SUBJECT: Final Biological Assessment and Request for Reinitiation of Consultation, Corps of Engineers Reservoir Operations

**BIOLOGICAL ASSESSMENT  
OF  
U.S. ARMY CORPS OF ENGINEERS  
RESERVOIR OPERATION ON THE  
MIDDLE RIO GRANDE OF NEW MEXICO**

October 31, 2011  
Amended February 15, 2013

Figure 4.2. Timeline of human activities since 1870 that have affected the Rio Grande.

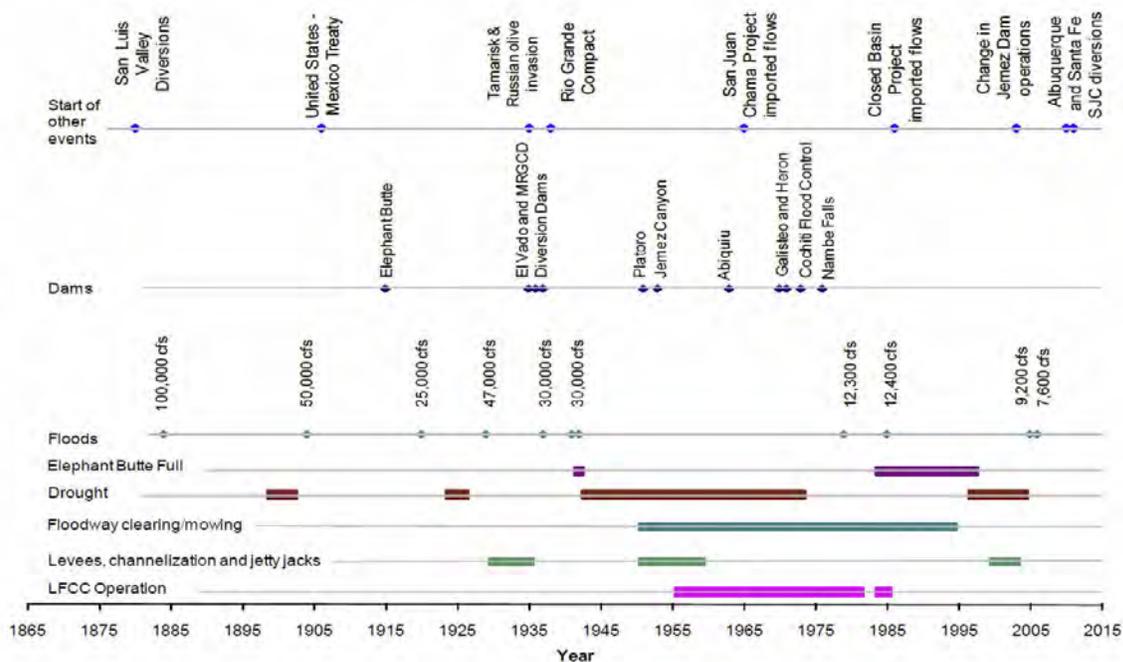
Figure 4.2 on page 37 shows droughts as occurring over a bar extending from 1943 to 1971. Please clarify if every one of these years was considered to exhibit drought conditions (see also question above on definition of drought used in the draft BA).

- a. Please explain what is being compared and is "similar." I.e., is the hydrograph similar to historical hydrograph conditions, or just during the period of time the river has been a regulated system?
- b. Figure 4.2 on page 37 shows what appears to be both decreasing magnitude and frequency of floods in the Middle Rio Grande since 1870, and in particular since 1940. This would be a potentially significant change in the hydrograph and counter to the statement above from page 39.

*Response: Clarifying text was added to read: "While the Middle Rio Grande has become a regulated river system, the general character and shape of the annual hydrographs above and below Cochiti have remained similar from 1975-2010, as shown in the graph below. Figure 4.4 displays the maximum, median, and minimum monthly discharge (cfs) of the Rio Grande at three locations on the mainstem based on U.S. Geological Survey data from 1975 to 2010."*

Figure 4.4. Monthly discharge (cfs) of the Rio Grande at Otowi gage, Cochiti Dam outlet, and Albuquerque gage, 1975-2010.

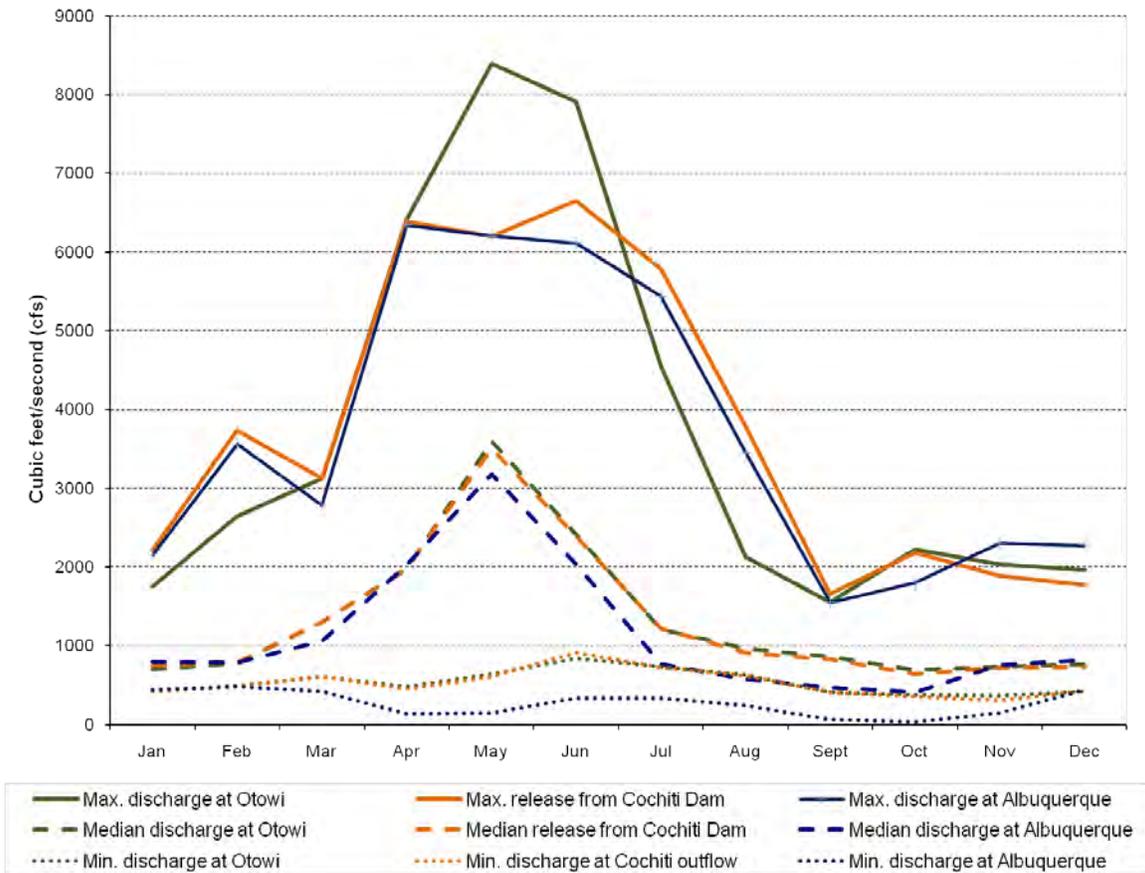
In Section 4.4.2 of the draft BA, which describes *Middle Rio Grande Discharge Characteristics*, Figure 4.4 on page 40 depicts mean monthly discharge at Otowi and Cochiti Dam outlet averaged across the years 1975-2008. The BA states that maximum and minimum discharges are not reflected on this figure.

Figure 4.5. Rio Grande flows at the USGS Rio Grande Otowi gage site (1975-2010).

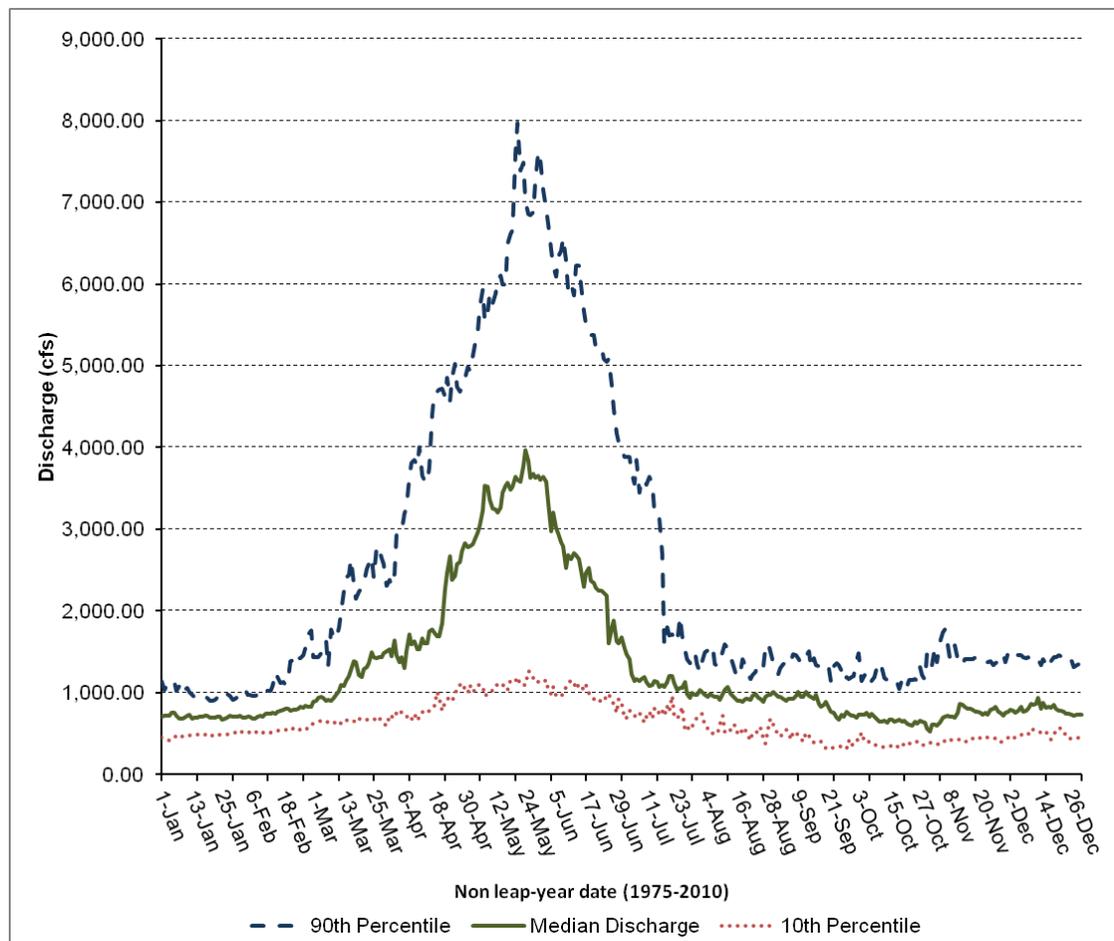
12. Section 4.4.2 on Middle Rio Grande Discharge Characteristics used to include the following statement (in the draft BA dated April 30, 2011), which was removed for the October 31, 2011 BA: "Since completion of Cochiti Dam, the frequency of large magnitude peak discharges has decreased in all reaches of the Rio Grande downstream of the dam as shown on Figure 4.5 (USACE 2007)." Please explain why this statement and the corresponding Figure 4.5 were removed, and if this report and statement from the draft BA were incorrect (and if so, please explain).

*Response: The figure and text were deleted because they were both inaccurate and contained erroneous information. Figure 4.5 made improper comparisons of gage data from widely differing periods-of-record, and did not account for differences in inflow magnitudes between periods. The statement in the text refers to*

Figure 6.1. Elevation of Elephant Butte Reservoir at end-of-month, 1917 to 2009.

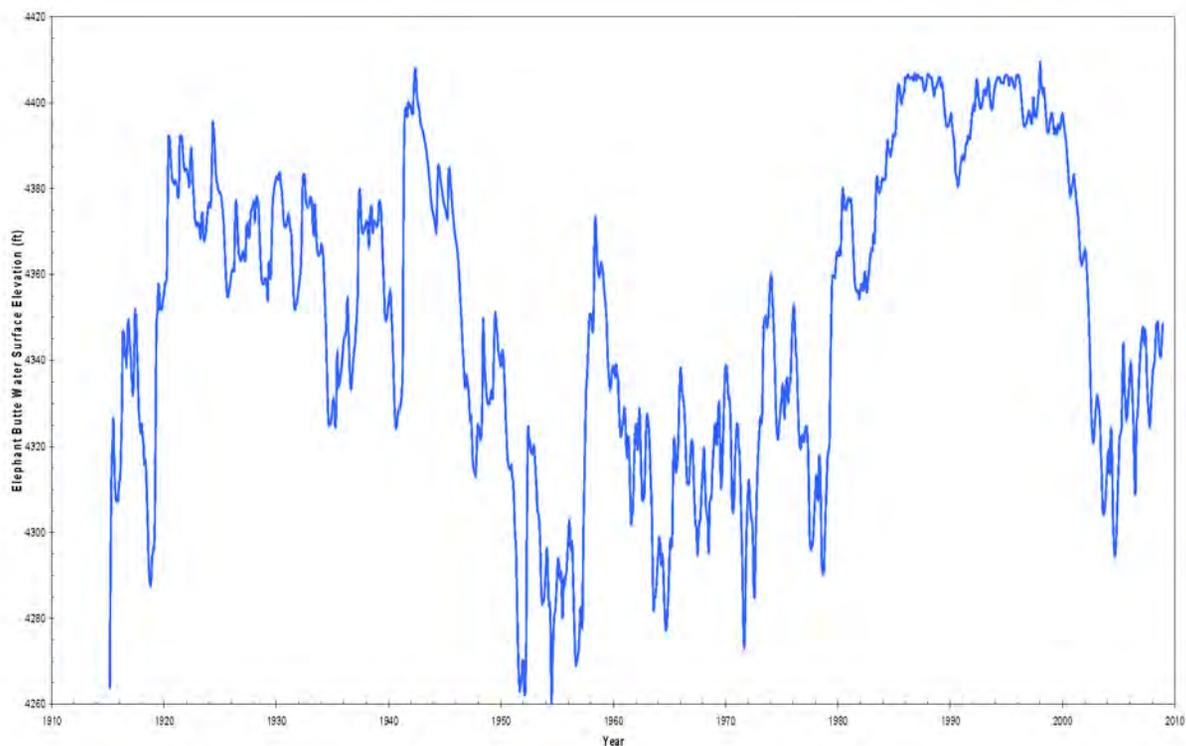
Page 82 states that the mid-1980s to mid-1990s were “a period of unprecedented storage levels in the reservoir”, referring to Elephant Butte Reservoir. However, Figure 6.1 appears to show a similar peak at Elephant Butte occurring in the 1940s. Please clarify.

Figure 6.7. Existing and expected future channel wetted surface area in the reach from Bernalillo to Isleta Diversion Dam, and the expected reduction between Bernalillo and Tijeras Arroyo.

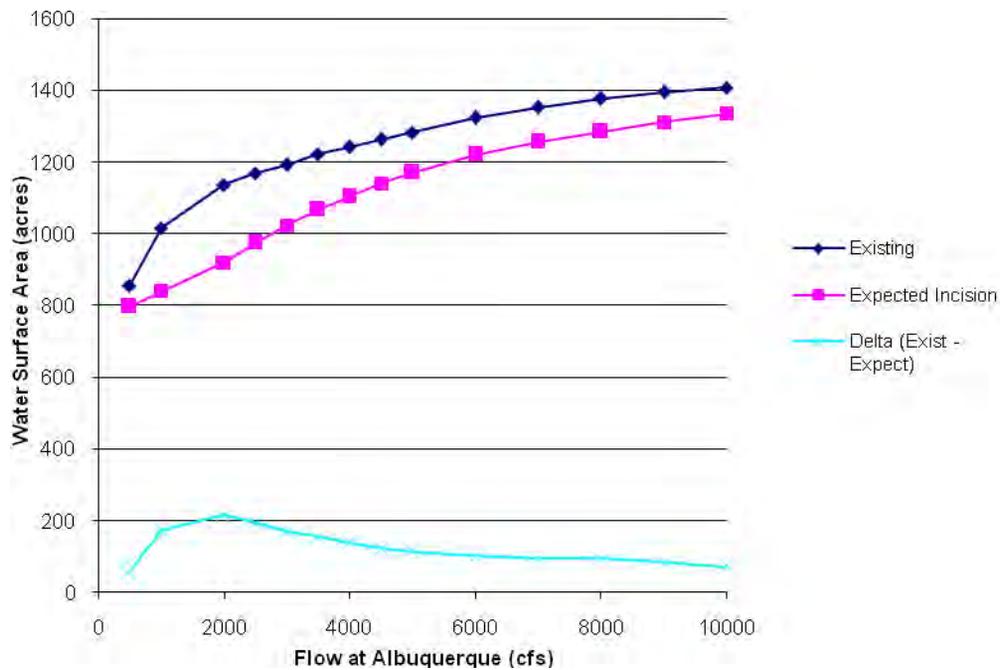
m. Section 6.1.4 on page 99 states that the formation of islands and pointbars are compensating for decreasing surface water inundation, demonstrated by silvery minnow population monitoring (Figure 5.1, 1993-2010). The minnow population monitoring trends provided in Figure 5.1 do not substantiate this conclusion as they provide no information on area of surface water inundation. Please provide the analysis showing how much increased surface water inundation is occurring from the formation of islands and pointbars, compared to decreased area of surface water inundation, to substantiate this statement in the BA. Please cite the best available information used by the Corps in this analysis, as required by 50 CFR402.14(d).

*Response: Section 6.1.4 describes the HEC-RAS hydraulic modeling conducted by the Corps to analyze the effects of incision. If the Service has the capability to run the HEC-RAS model, the Corps will provide the model runs. Figure 6.7 depicts the decrease in water surface area expected as a result of future incision over the range of flows from 50 to 10,000 cfs. The revised BA describes the very limited extent of suitable flycatcher habitat within the affected reach, and small expected change to groundwater elevations based on data from monitoring piezometers within the area.*
